ADDENDUM NUMBER: One

ADDENDUM NUMBER: Two

PROJECT: Government of Canada Driver Training Building Regina, Saskatchewan	ADDENDUM NUMBER: M-2
PROJECT NO : 05.004.C	DATE : June 17, 2016

PROJECT: Government of Canada Driver Training Building Regina, Saskatchewan	ADDENDUM NUMBER: M-3
PROJECT NO : 05.004.C	DATE : June 20, 2016

Msk-01

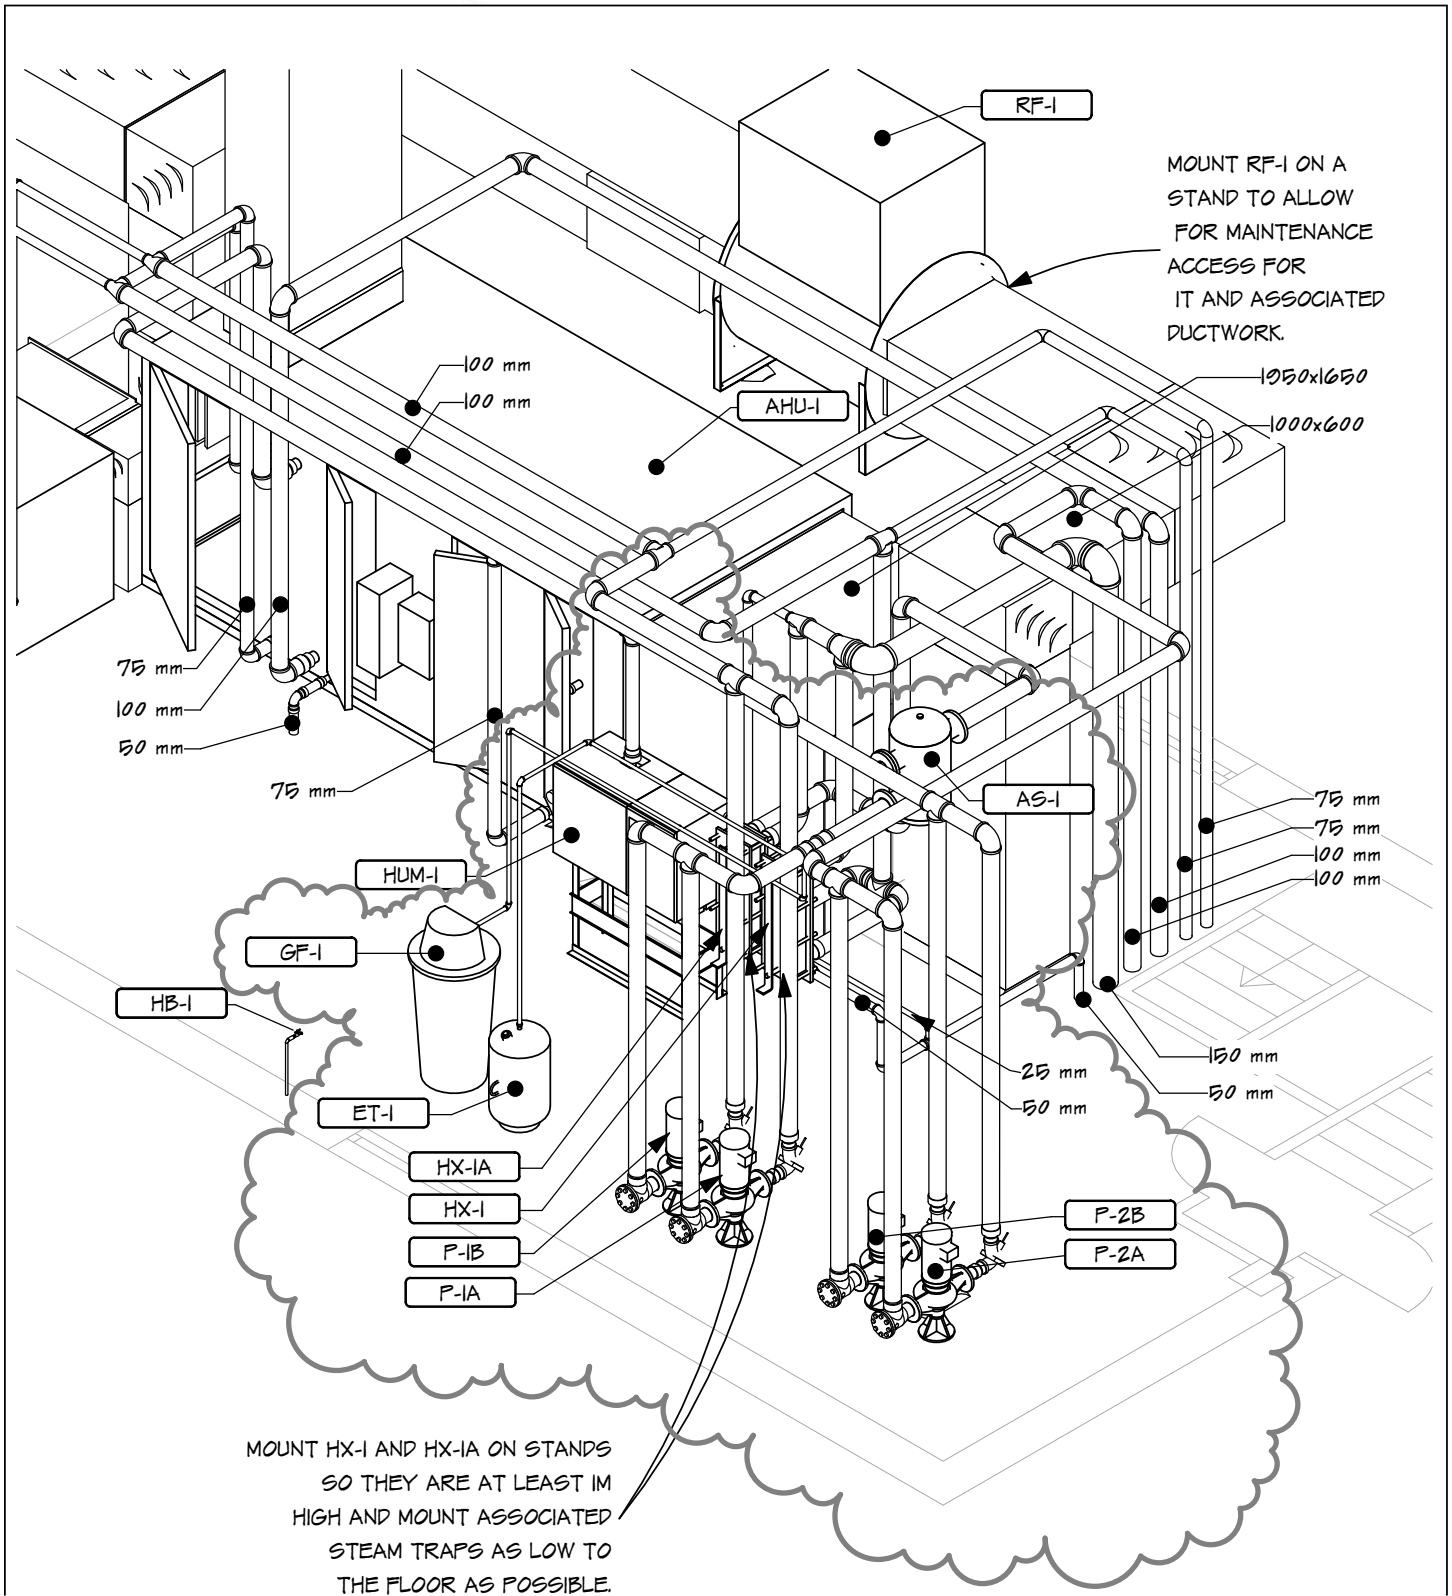
1. Refer to drawing M1.1:
 - .1 Add the piping symbols shown on drawing Msk-01r1 (dated 2016.06.17 as attached to this addendum) to the Piping Symbol Legend.
2. Refer to drawing M4.2:
 - .1 Refer to detail 3/M4.2 "Penthouse Isometric View" : revise detail as shown on drawing Msk-02r1 (dated 2016.06.17 as attached to this addendum).
 - .2 Refer to detail 2/M4.2 "New Penthouse Mechanical Room Plan": revise detail as shown on drawing Msk-05r1 (dated 2016.06.17 as attached to this addendum)
3. Refer to drawing M5.1:
 - .1 Refer to detail 1/M5.3 "Heating and Cooling Schematic": revise detail as shown on drawings Msk-03r1 (dated 2016.06.17 as attached to this addendum) and Msk-04r1 (dated 2016.06.17 as attached to this addendum).

Drawing No.
Msk-06
Rev :

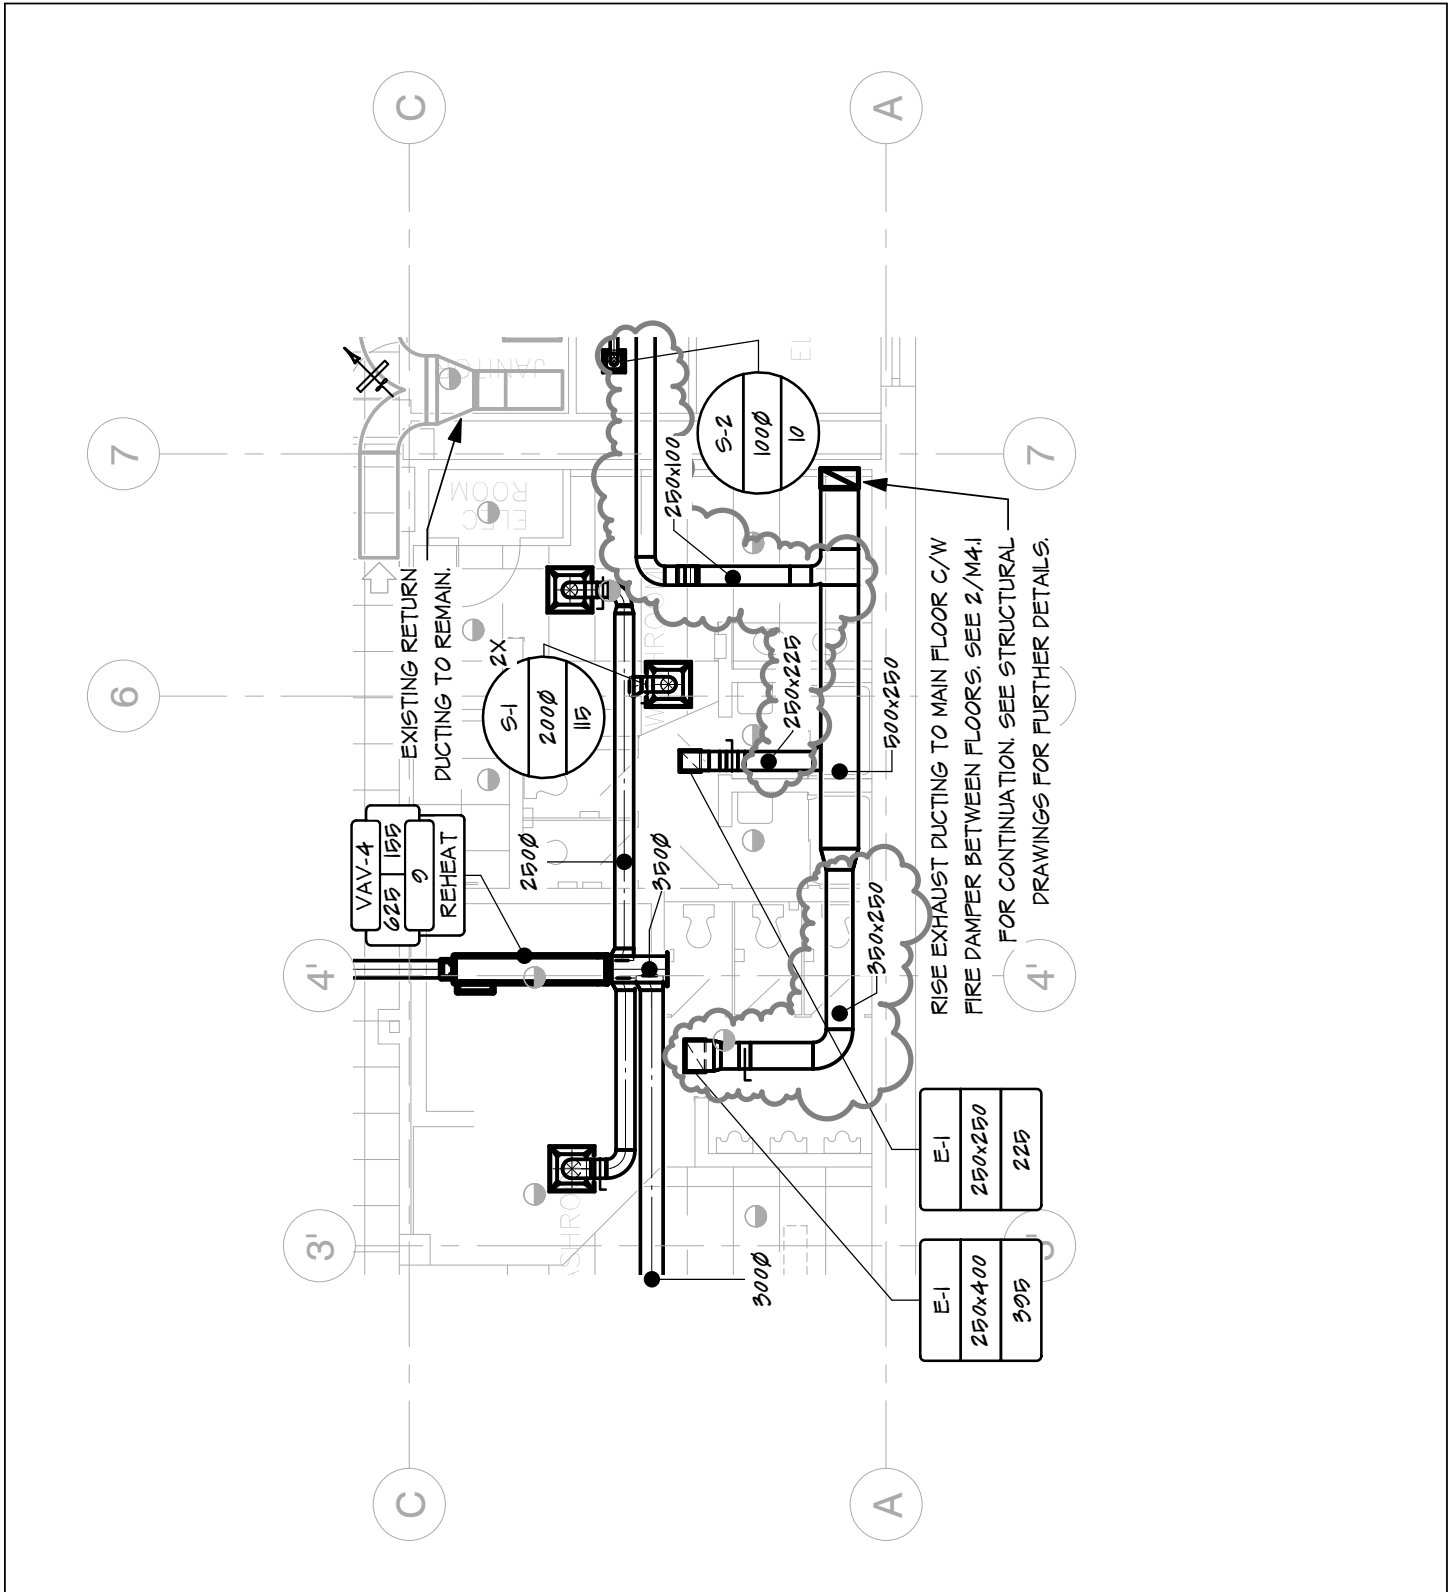
- .1 Refer to drawing M4.1 detail 1/M4.1 "New Basement HVAC" : Revise the ductwork as shown on drawings Msk-06, Msk-07, and Msk-08, all dated 2016.06.20, and issued with this addendum.
- .2 Refer to drawing M4.1 detail 2/M4.1 "New Main Floor HVAC" : Revise the ductwork as shown on drawings Msk-09, dated 2016.06.20, and issued with this addendum.
- .3 Refer to drawing M4.2 detail 1/M4.2 "New Second Floor HVAC" : Revise the ductwork as shown on drawings Msk-10, dated 2016.06.20, and issued with this addendum.
- .4 Refer to drawing M4.2 detail 2/M4.2 "New Penthouse Mechanical Room" : Revise the ductwork as shown on drawings Msk-11, dated 2016.06.20, and issued with this addendum.

Drawing No.
Msk-08
Rev :

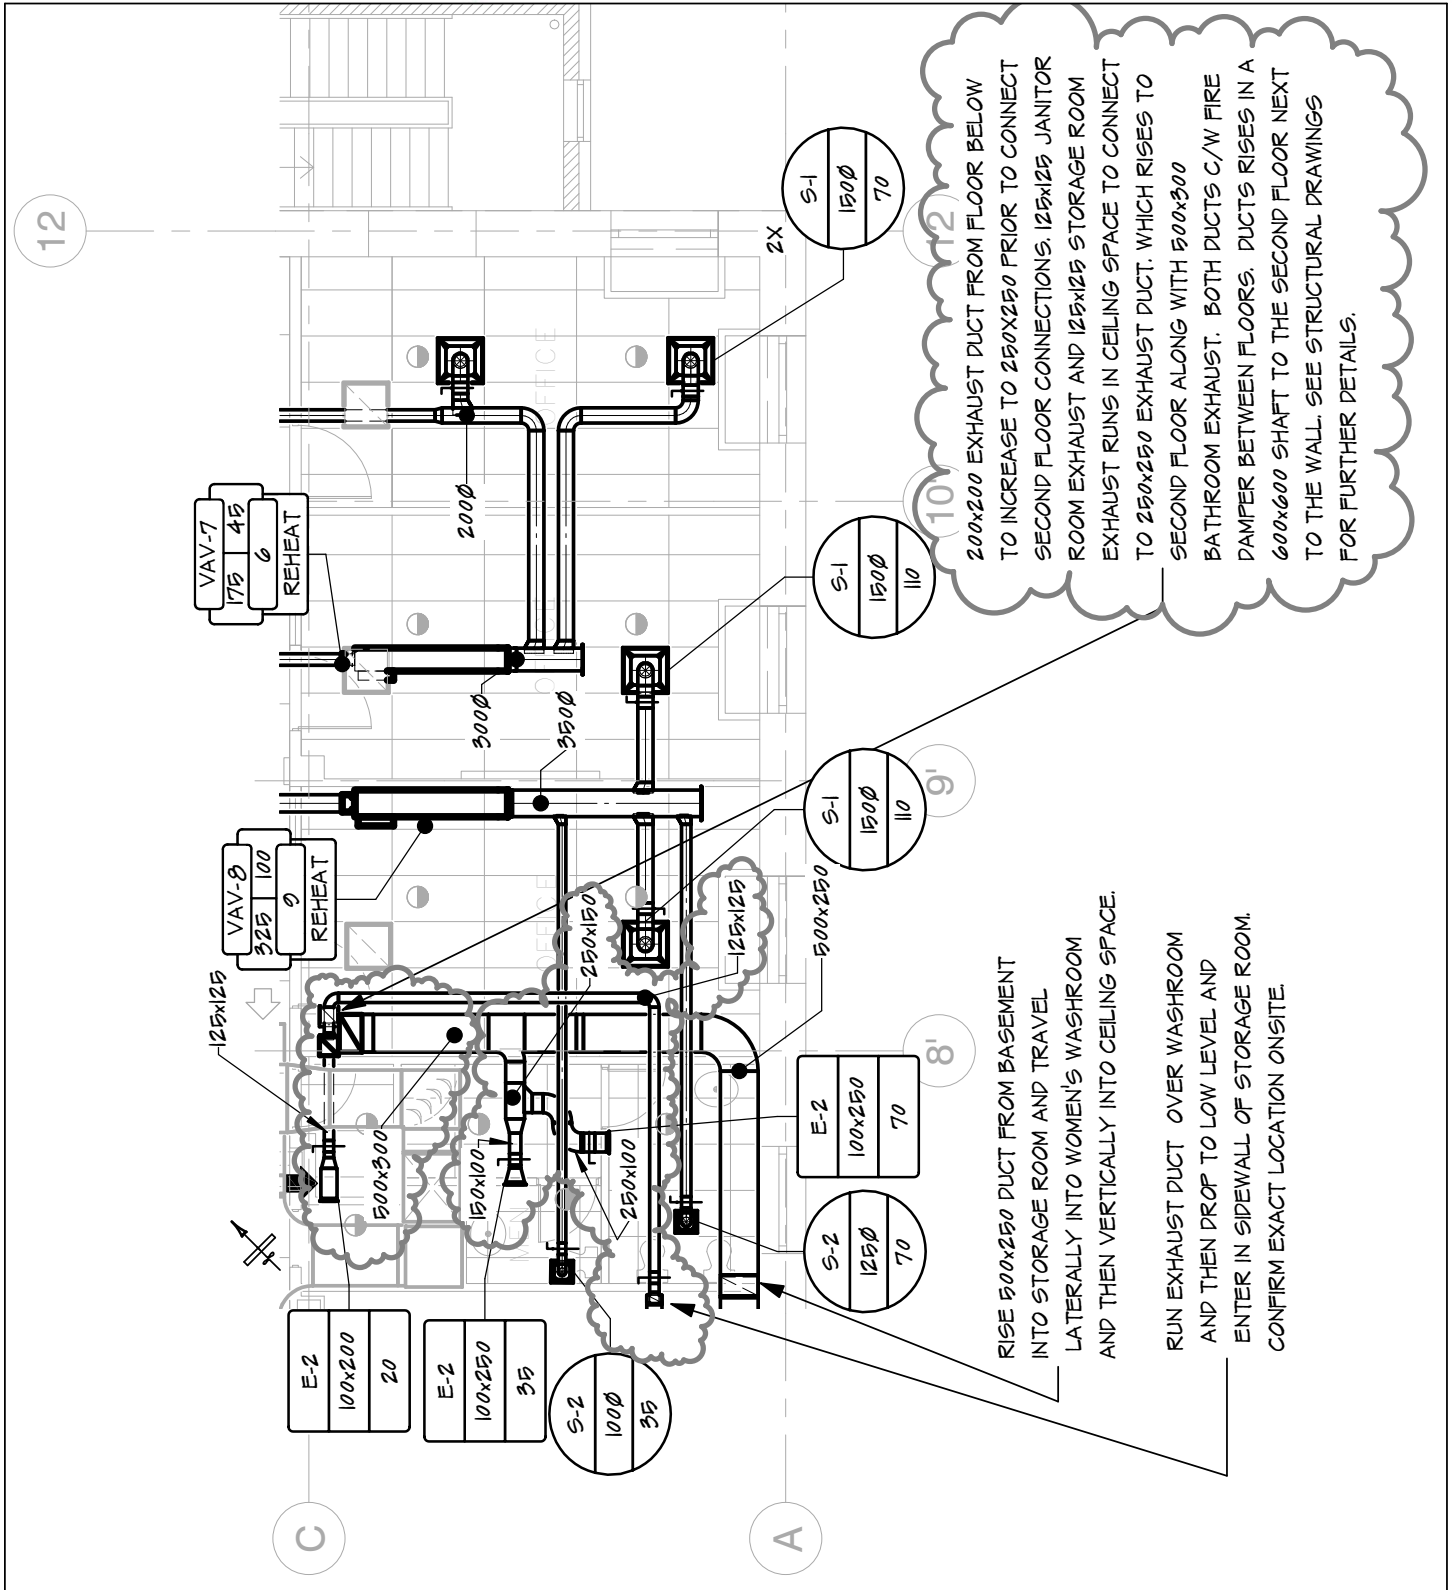
200x200 EXHAUST DUCT FROM FLOOR BELOW TO INCREASE TO 250x250 PRIOR TO CONNECT SECOND FLOOR CONNECTIONS. 125x125 JANITOR ROOM EXHAUST AND 125x125 STORAGE ROOM EXHAUST RUNS IN CEILING SPACE TO CONNECT TO 250x250 EXHAUST DUCT. WHICH RISES TO SECOND FLOOR ALONG WITH 500x300 BATHROOM EXHAUST. BOTH DUCTS C/W FIRE DAMPER BETWEEN FLOORS. DUCTS RISES IN A 600x600 SHAFT TO THE SECOND FLOOR NEXT TO THE WALL. SEE STRUCTURAL DRAWINGS FOR FURTHER DETAILS.

Drawing No.
Msk-09
Rev :

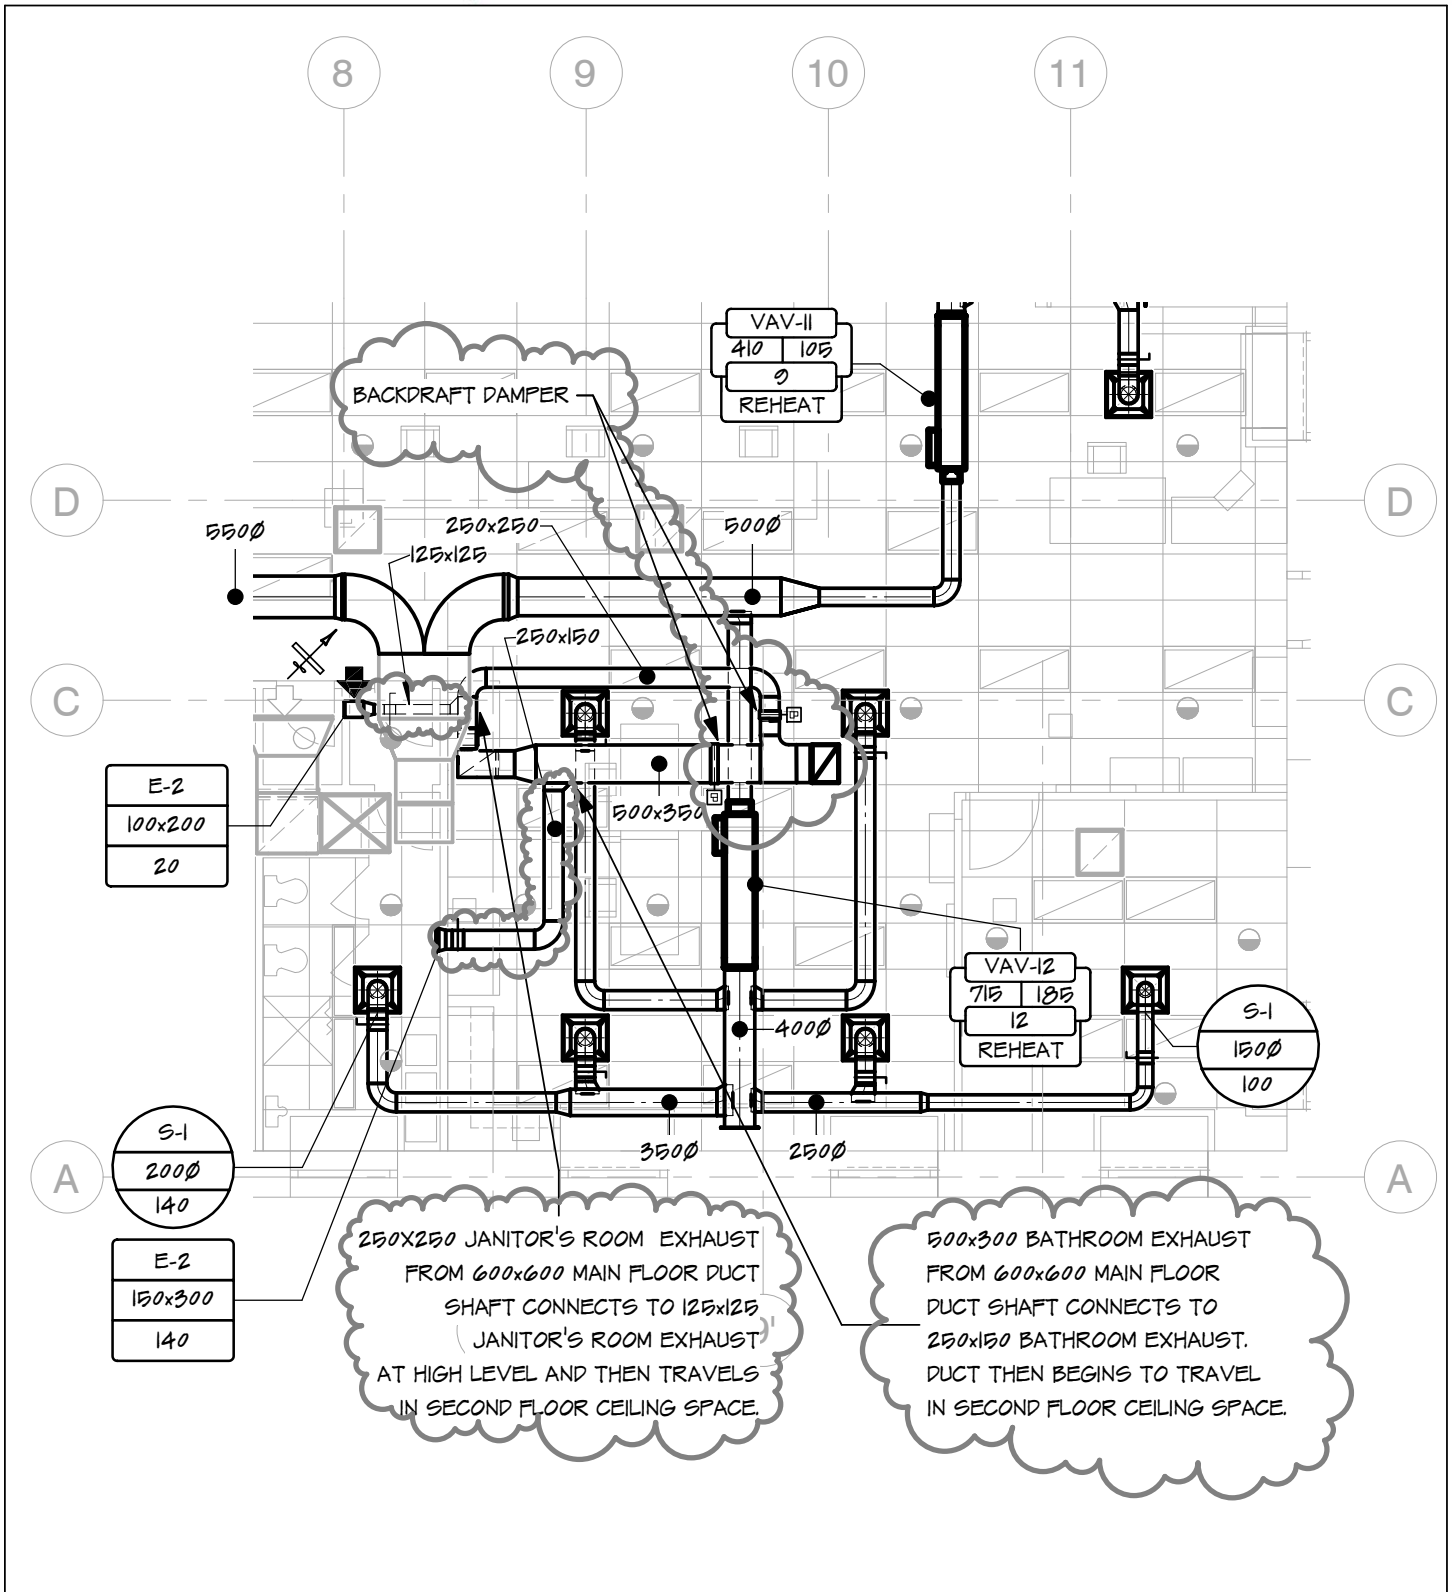
RISE 500x250 DUCT FROM BASEMENT INTO STORAGE ROOM AND TRAVEL LATERALLY INTO WOMEN'S WASHROOM AND THEN VERTICALLY INTO CEILING SPACE.

RUN EXHAUST DUCT OVER WASHROOM AND THEN DROP TO LOW LEVEL AND ENTER IN SIDEWALL OF STORAGE ROOM. CONFIRM EXACT LOCATION ON-SITE.
